January 12, 2024

**ADDENDUM NO. 1**

**PROJECT TITLE**  
 WALL BUILDING CONFERENCE  
 CENTER RENOVATION  
 COASTAL CAROLINA UNIVERSITY  
 CONWAY, SOUTH CAROLINA  
 STATE PROJECT NO. H17-N141-CB

**DRAWING TITLE**  
 FLOOR PLANS

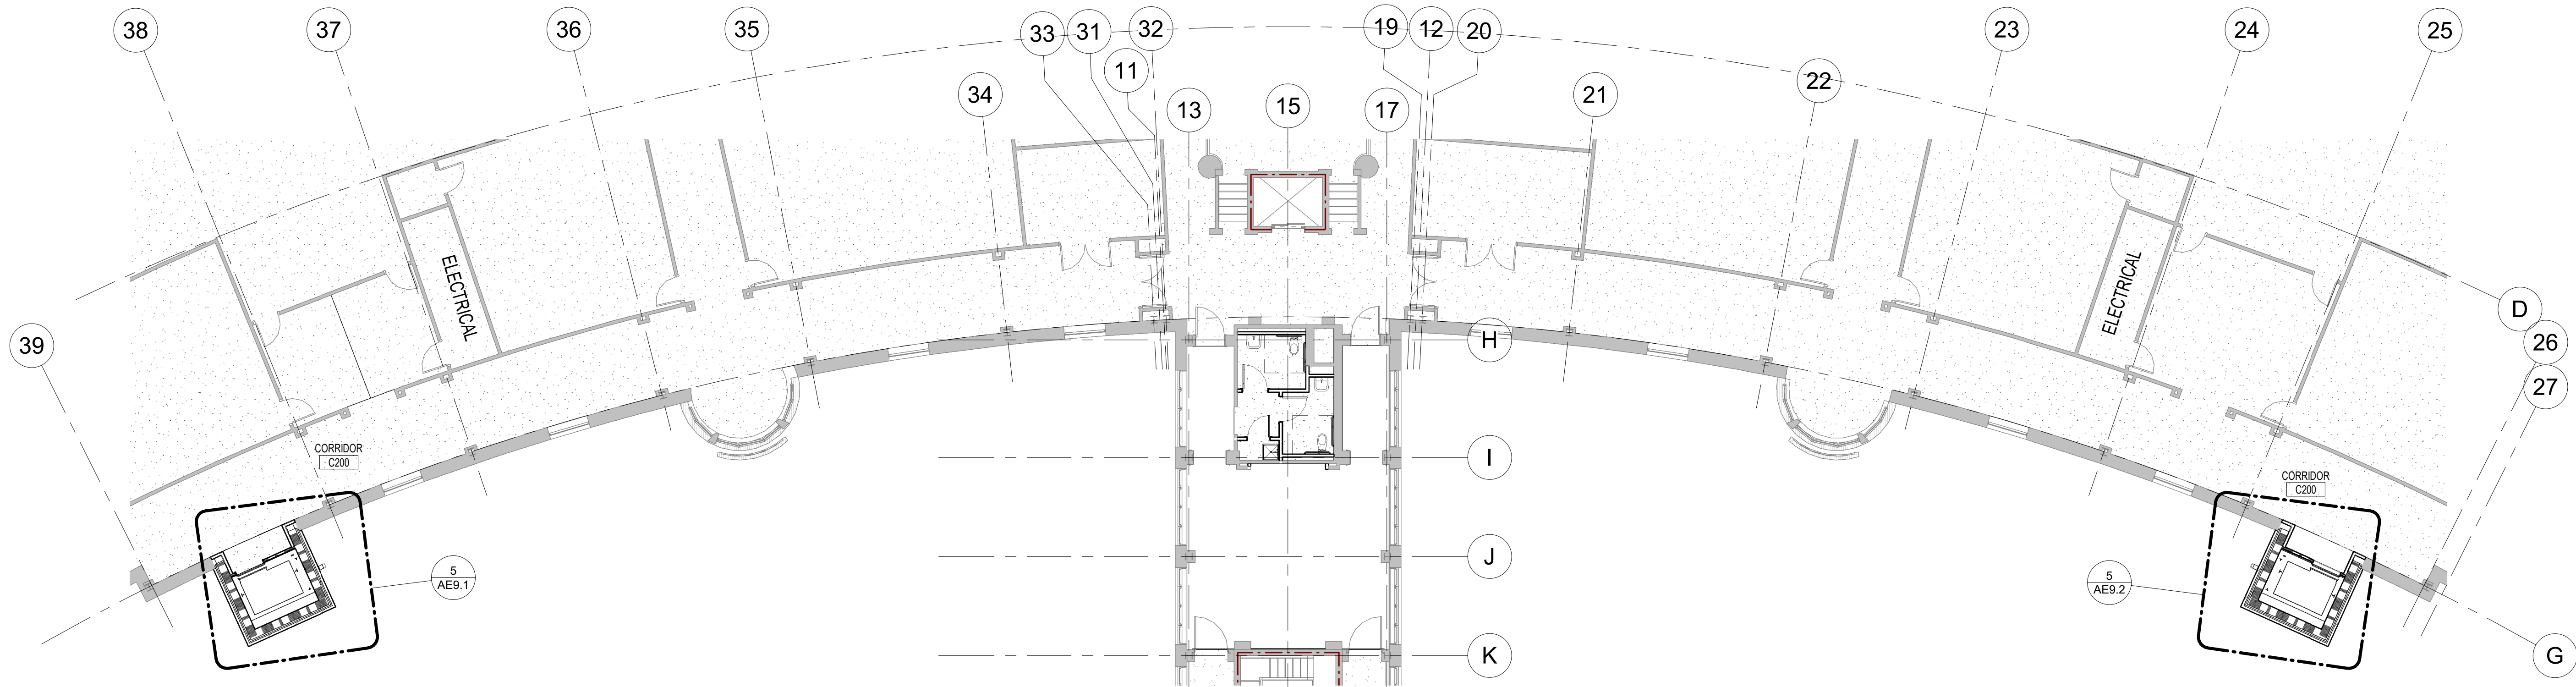
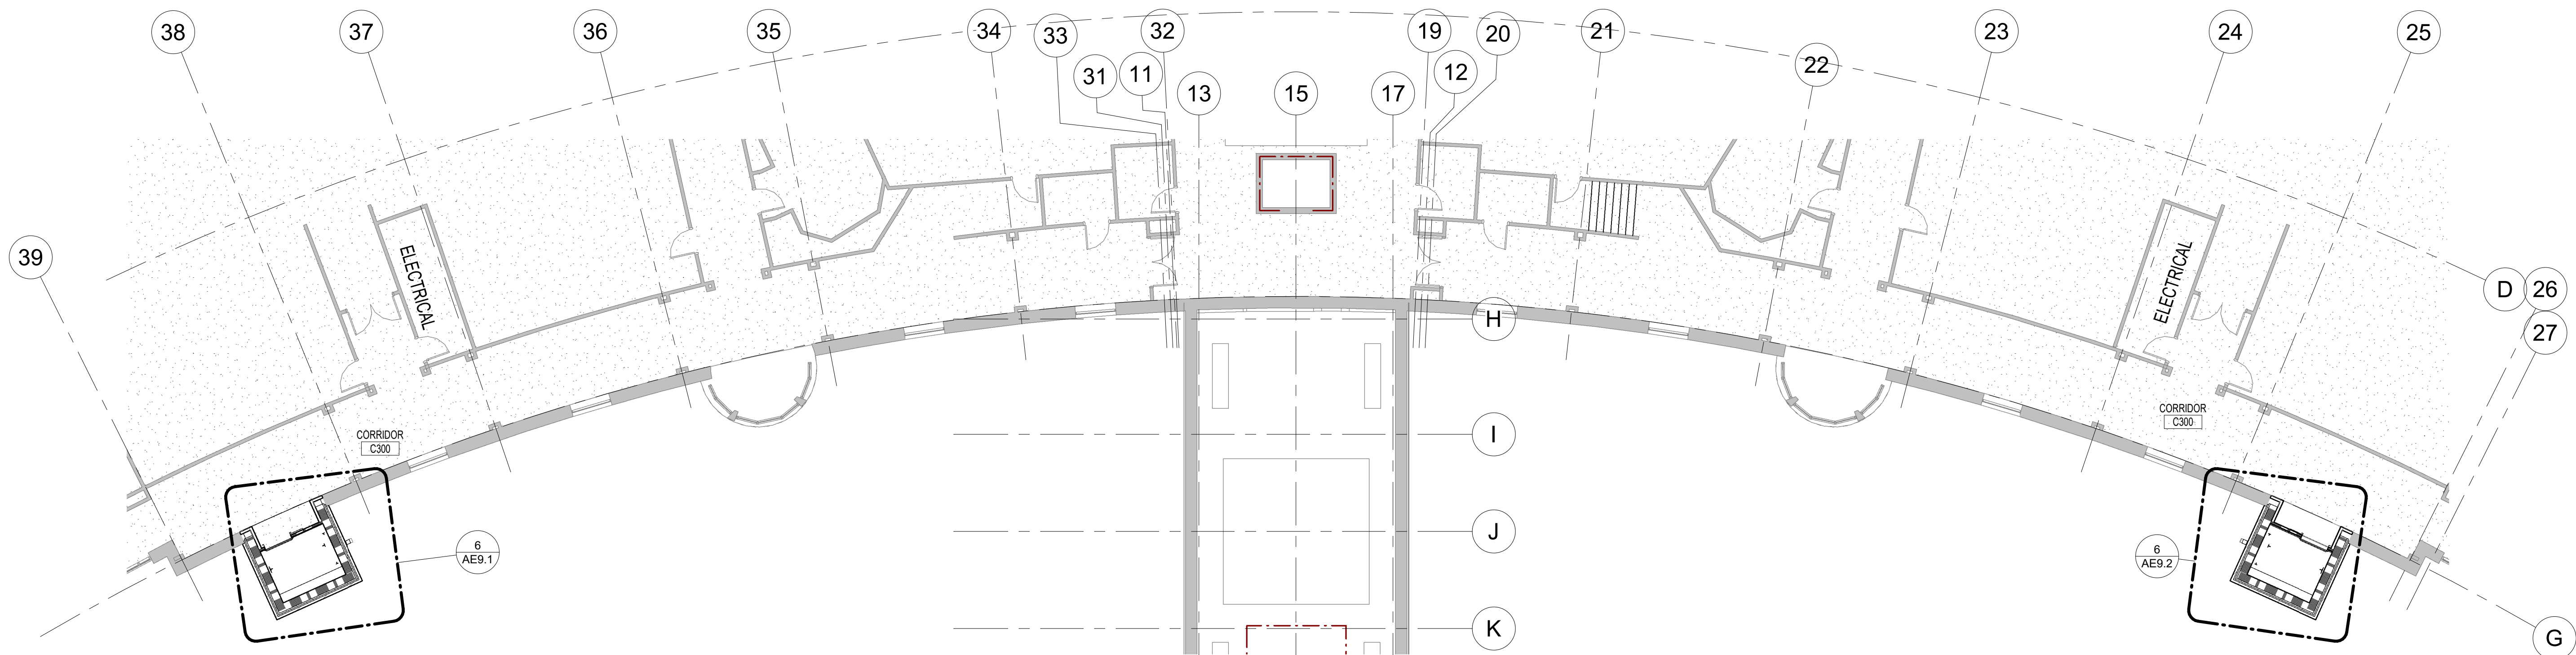
<u>Item No.</u>	<u>Description</u>
1.	<u>Revision:</u> Reference Drawing AE1.0, FLOOR PLANS. Added linework and notes tying elevator foundation drain to nearby yard inlet. This sheet is attached at the end of this Addendum.
2.	<u>Revision:</u> Reference Drawing AE3.1, INTERIOR AND EXTERIOR PARTITION TYPES. Added plan details for new elevator wall tie into existing wall. This sheet is attached at the end of this Addendum.
3.	<u>Revision:</u> Reference Drawing AE9.1, VERTICAL CIRCULATION. Added plan detail call outs to all enlarged plans. This sheet is attached at the end of this Addendum.
4.	<u>Revision:</u> Reference Drawing AE9.2, VERTICAL CIRCULATION. Added plan detail call outs to all enlarged plans. This sheet is attached at the end of this Addendum.
